**TOWN OF YORKTOWN
PLANNING BOARD**

**PUBLIC MEETING AGENDA
YORKTOWN TOWN HALL BOARD ROOM
363 Underhill Avenue, Yorktown Heights, NY 10598**

**October 3, 2022
7:00 PM**

REVISED ARCHITECTURAL RENDERING

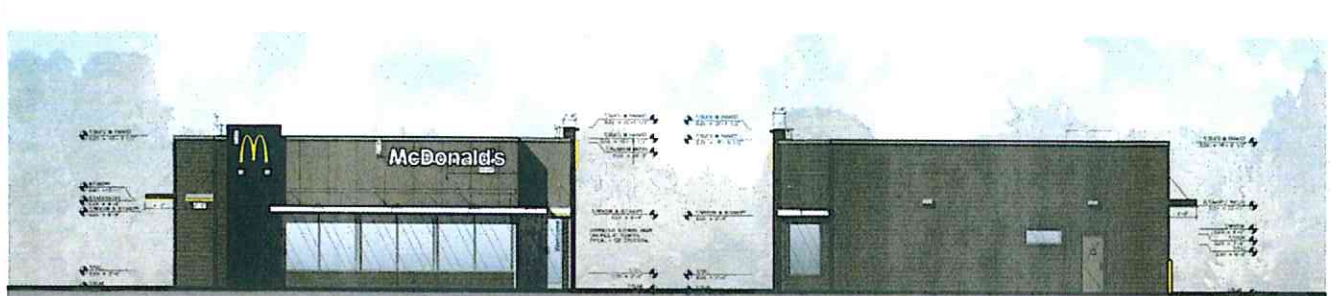
The applicant is proposing a slight change to the previously approved plan for the building architecture from the approved faux brick pattern to a more uniform plank pattern while maintaining similar colors as shown in the rendering submitted.

- The colors on the exterior rendered elevation drawings don't relate precisely and reads much darker than the proposed new material and color listed which is more muted and softer. The proposed new material incorporated, fiber cement panel by Hardiplank in the color of "Timber Bark", is acceptable to the Board.
- The rail supporting the sign letters is white on the drawings but should match or be similar to the corresponding building color.
